To: All Service Providers
From: M. Angela Foraker, Executive Director
Strategy, Sourcing, & Support
Date: November 4, 2022
Re: Addendum #1 for ITB 21368 – MetroHealth Clinic Upgrades at Clara Westropp, Mound, and Glenville

This Addendum #1 reflects the following:

New MetroHealth
ODH
SBHC
Health Care Expansion Program

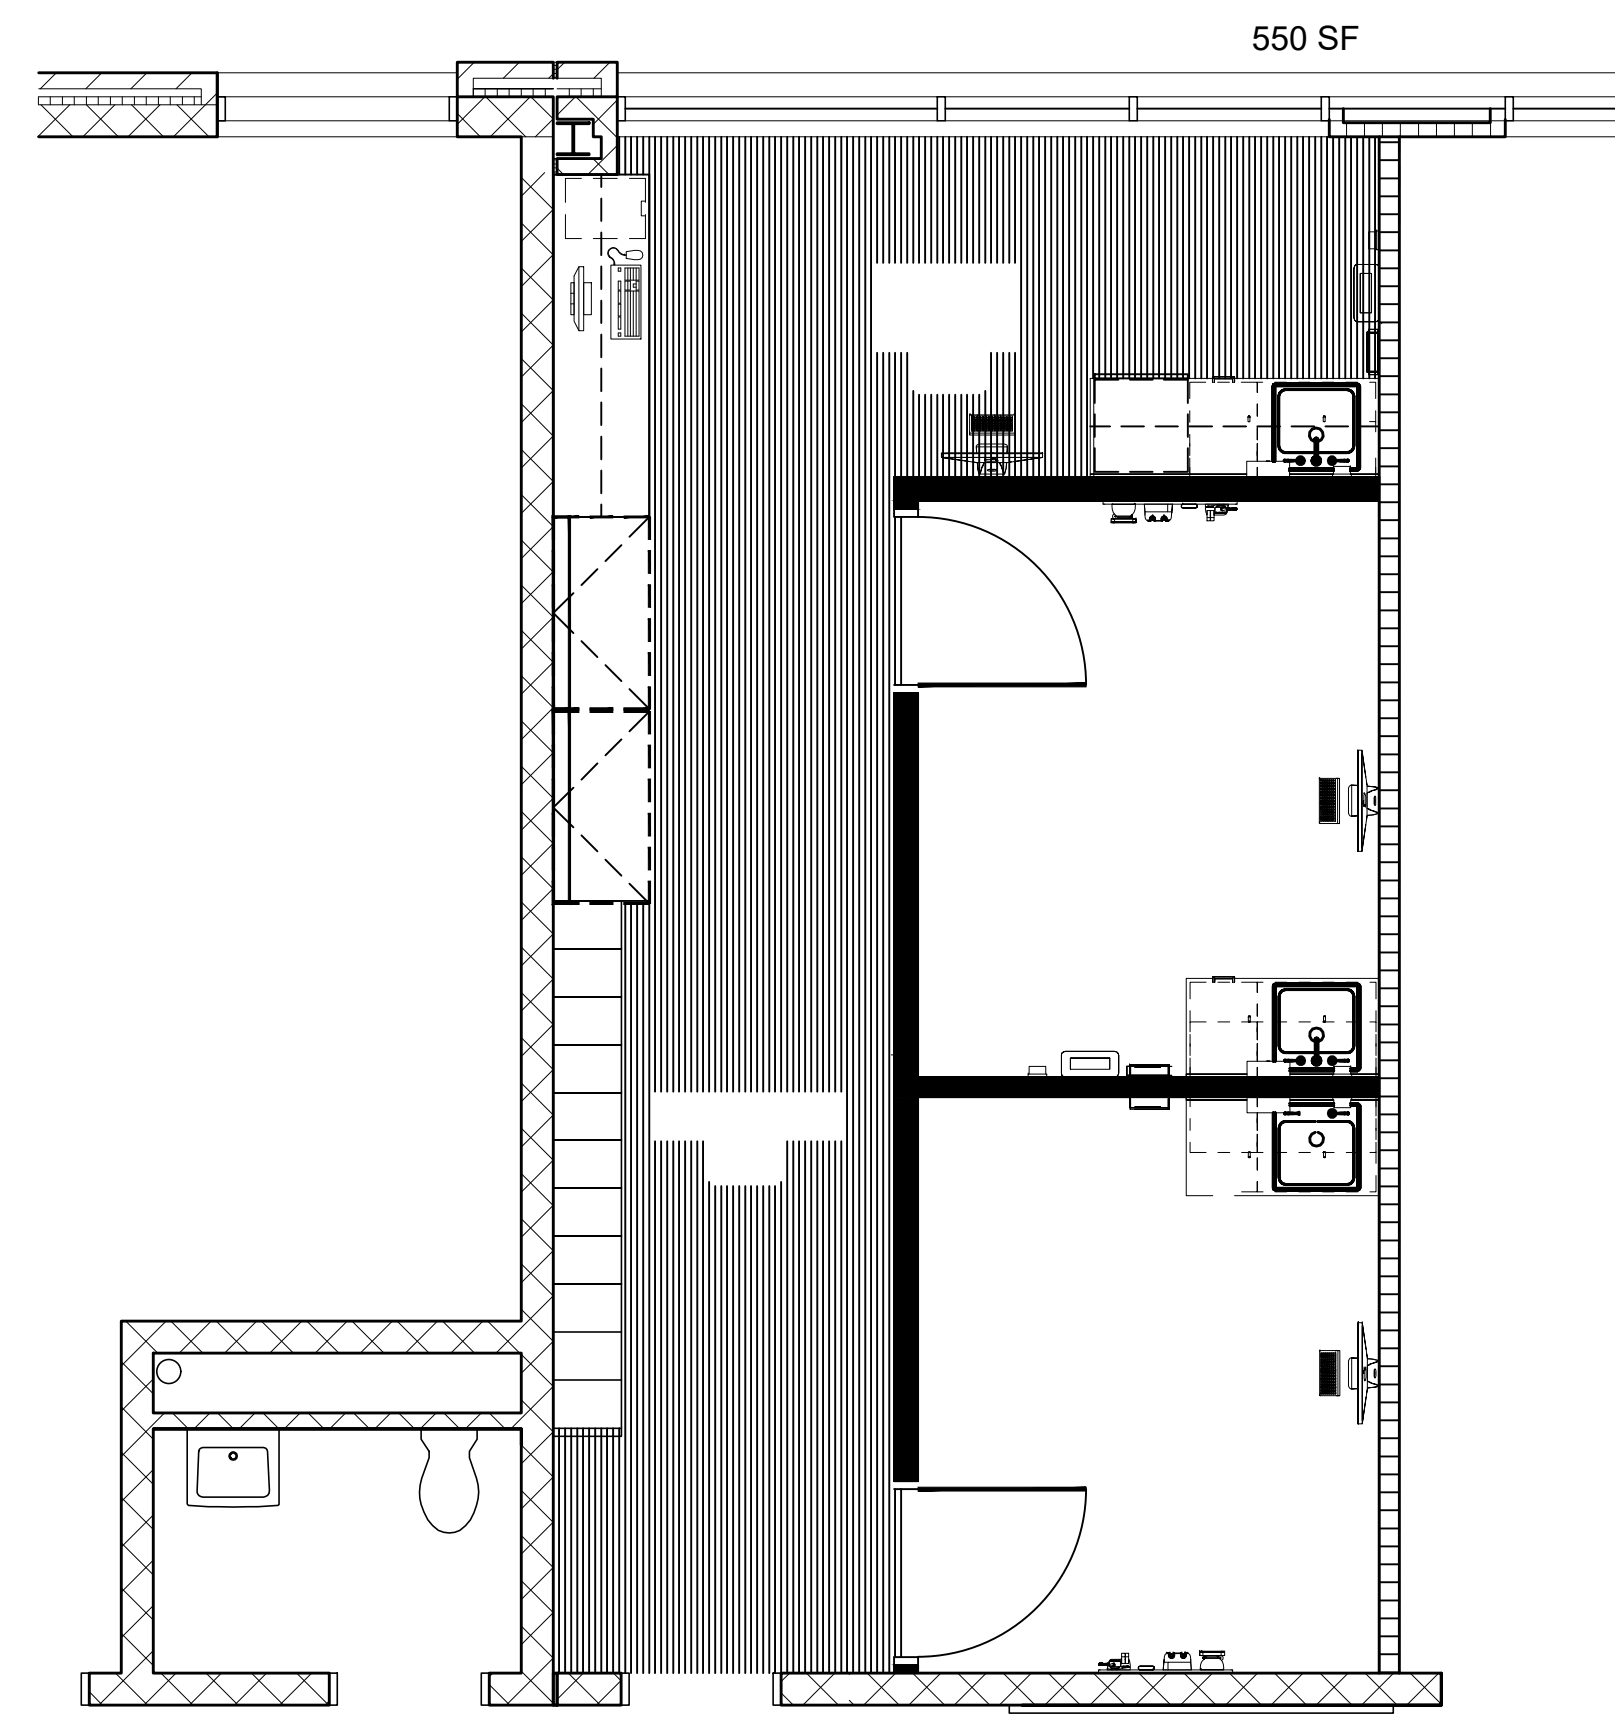
19. What is the hexagon symbol on proposed floor plan drawing(Clara Westropp)?

See Sheet A2.0 for notes

Scale: Date: 11.04.2022 Sheet: **A4.0**

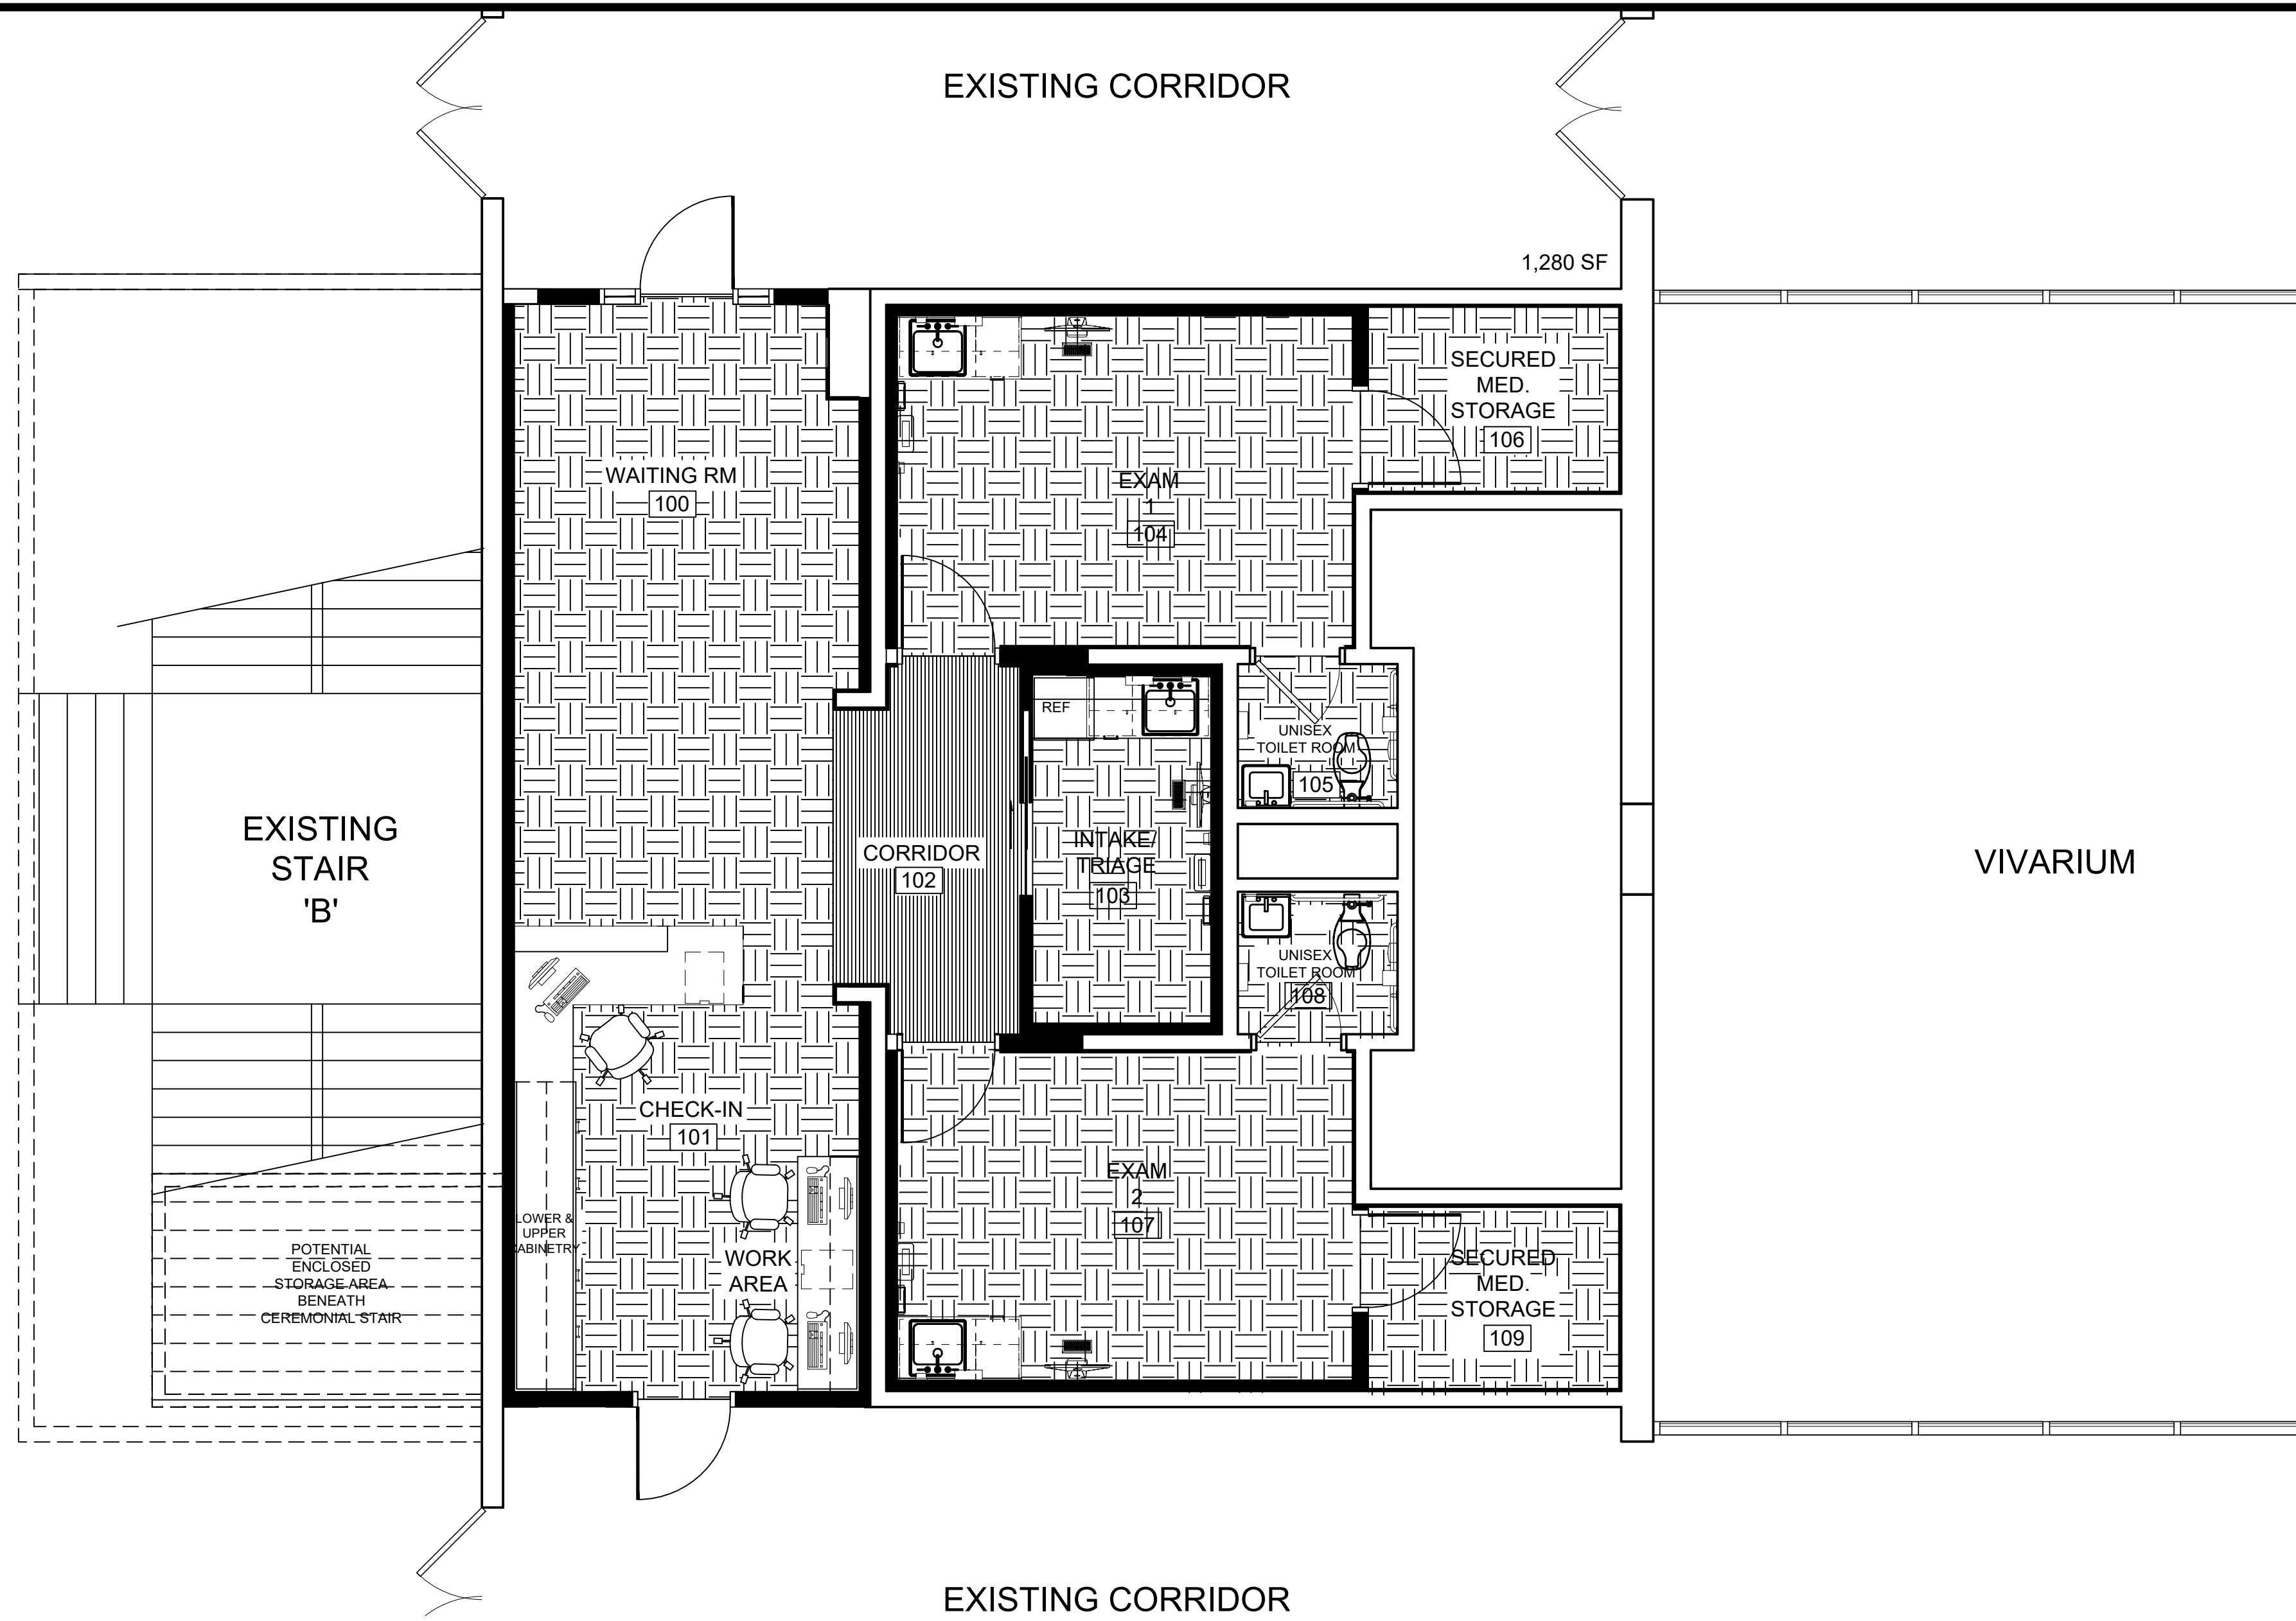
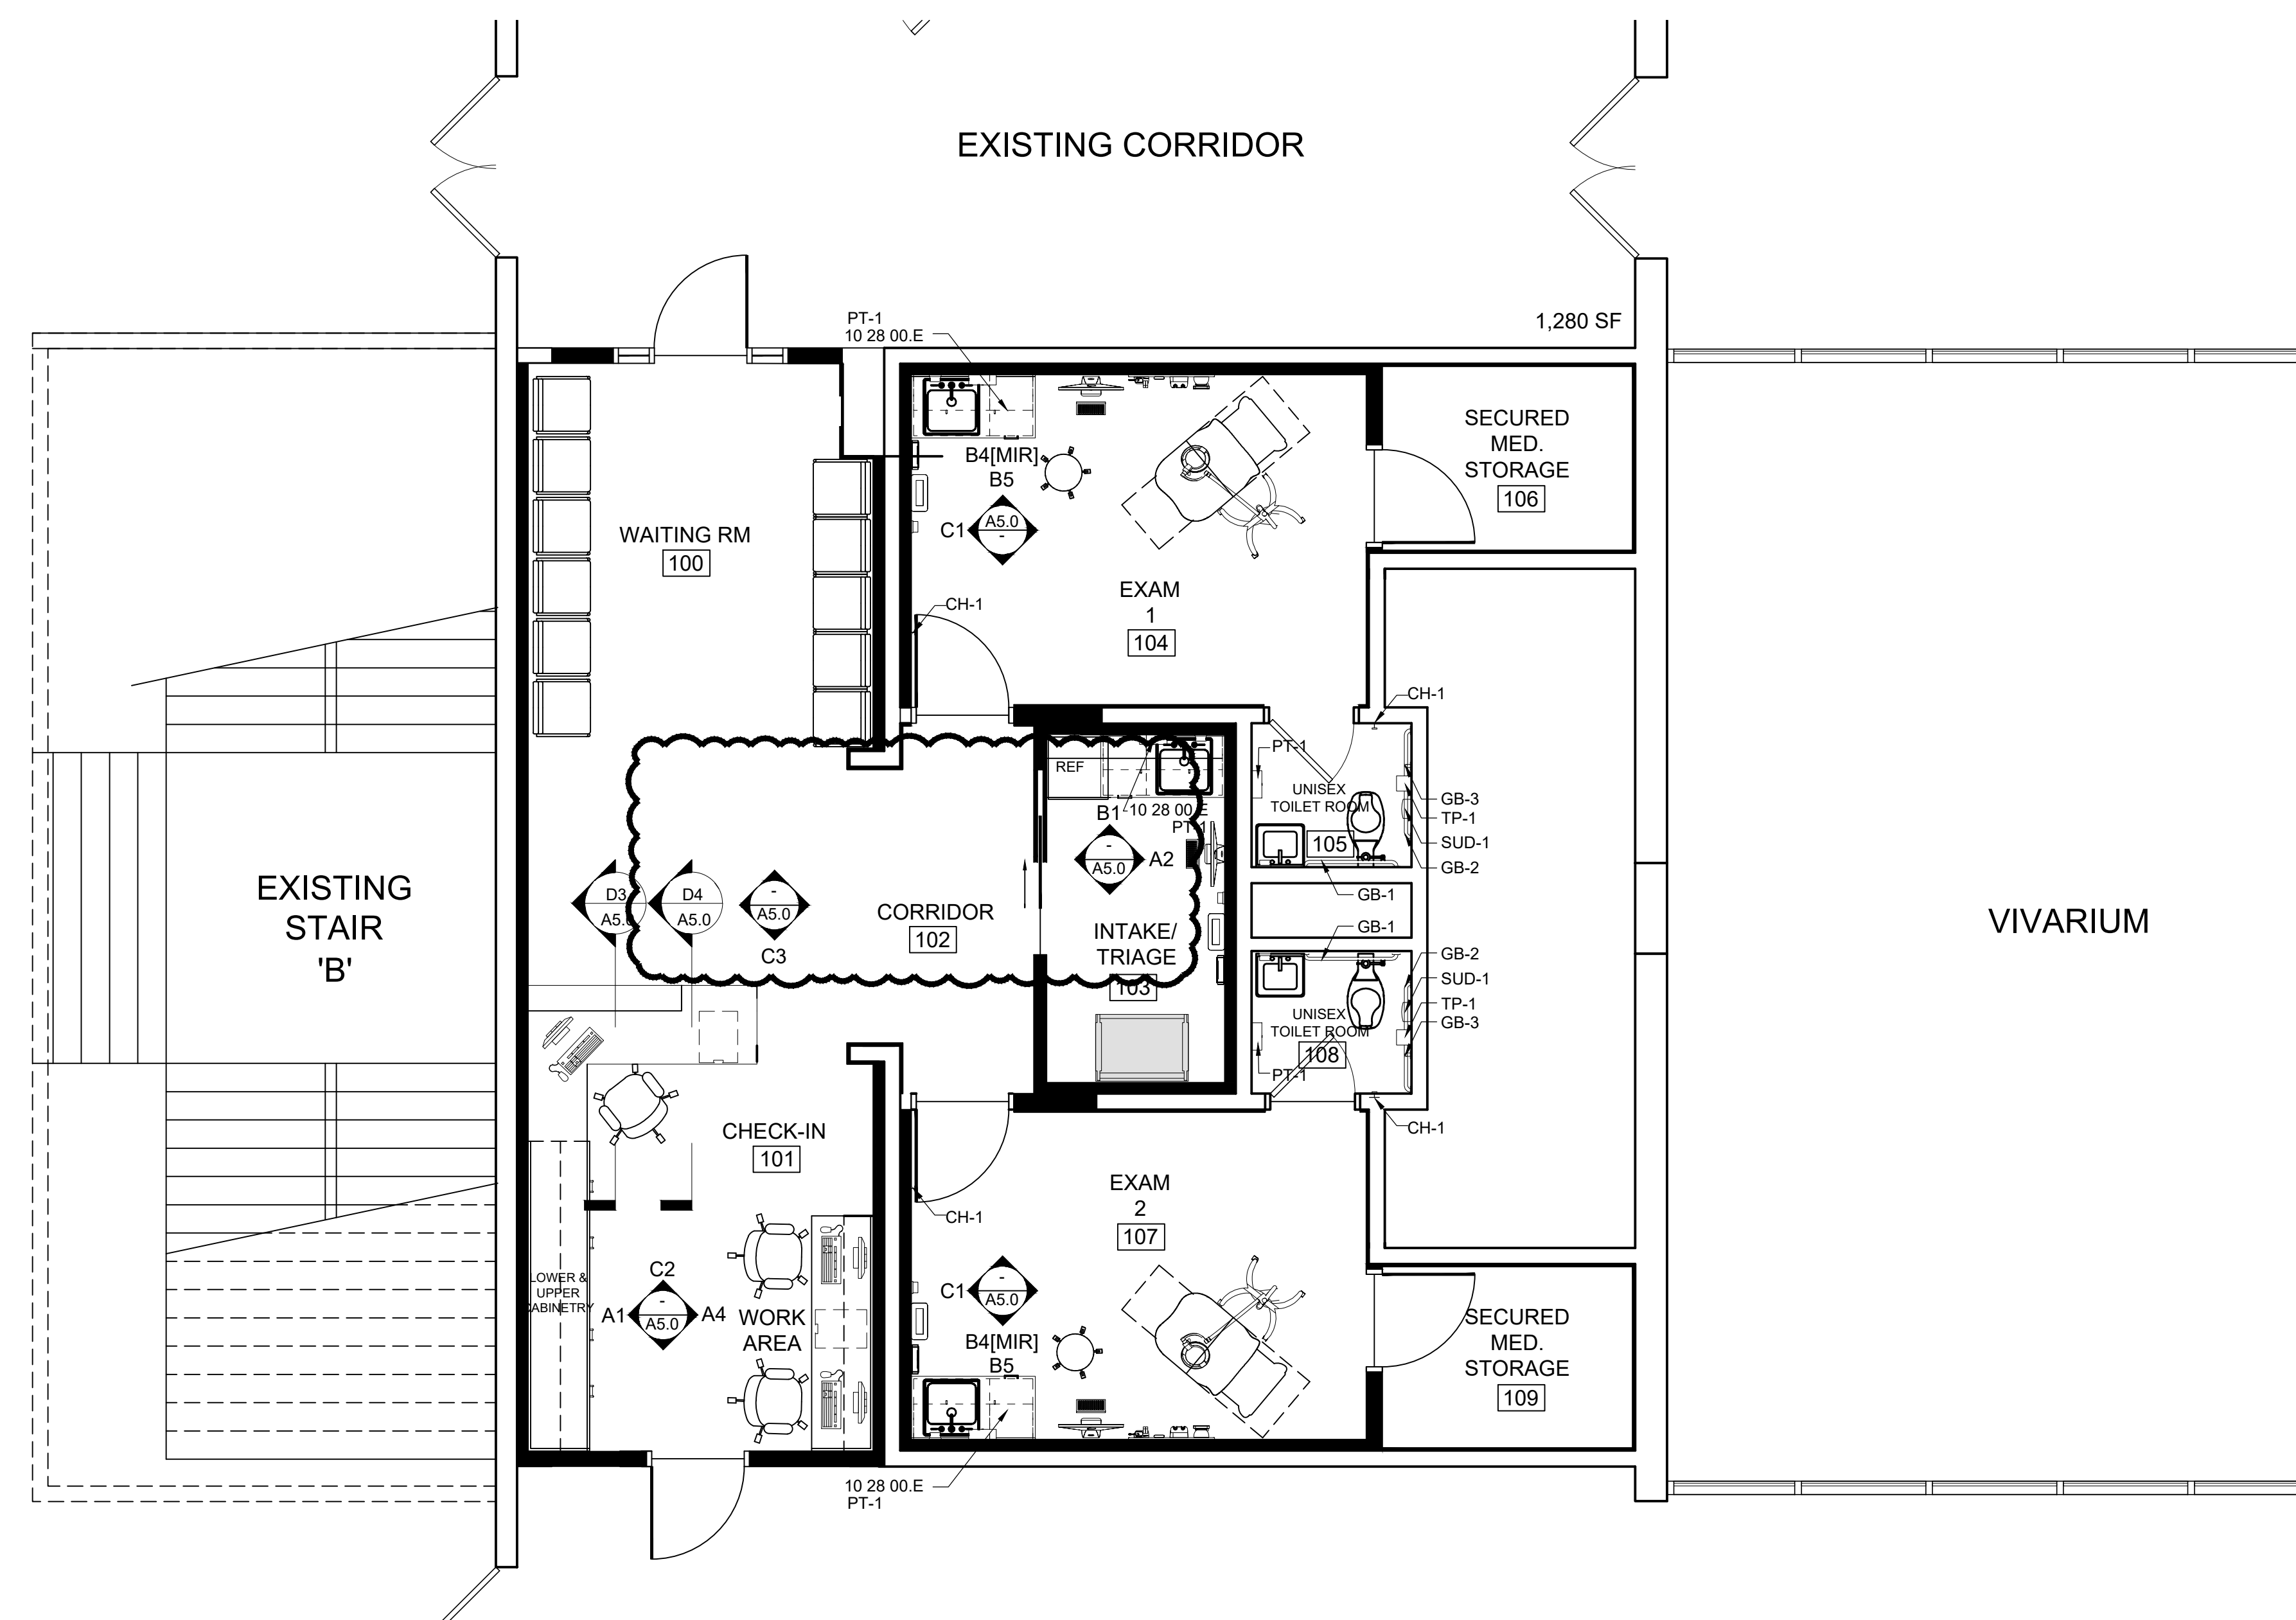
10. On the equipment/furniture plan (A4.0), elevation marker A4/A5.0 is used at the Check In Work Area. That elevation is labeled Staff Break Room and the layout/elevation do not match. What are the casework requirements for this room(Clara Westropp)?

12. Elevation A3 for Triage/Intake does not match the floor plan layout. What are the casework requirements for this room(Clara Westropp)?

13. Elevation A1/A5.0 does not match the floor plan. The floor plan shows 4 base and 4 wall cabinets, the elevation shows 2 base and 1 wall cabinet. Which is correct(Clara Westropp)?

14. The layout for Intake Triage (2/A4.0) and the elevations (C1 & A4/A5.0) do not match. What are the casework requirements for this room(Mound)?

See Sheets A4.0 and A5.0 for Revisions

See Sheets A4.0 and A5.0 for Revisions

See Sheets A4.0 and A5.0 for Revisions

See Sheets A4.0 and A5.0 for Revisions
